## Introduction of brake pad quality SAF 577 in brake pad repair kits 3 057 0096 00 (SBS2220H0) and 3 057 0015 00 (SBS2220H01) as of March 2021

**Version „new“**

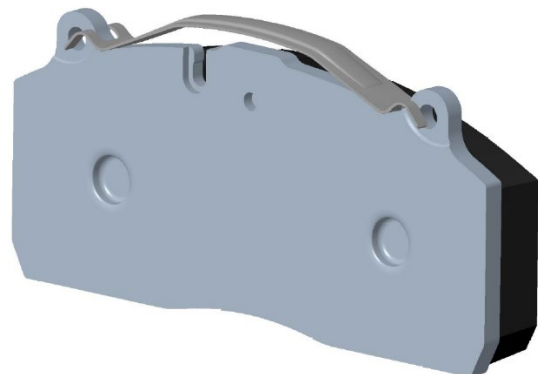
In the course of the changeover, two back plate and spring designs are currently still used in the aftermarket.

Both versions can be used until the final conversion. Brake pad sets are always packaged and shipped by type, so that mixed installation is excluded.
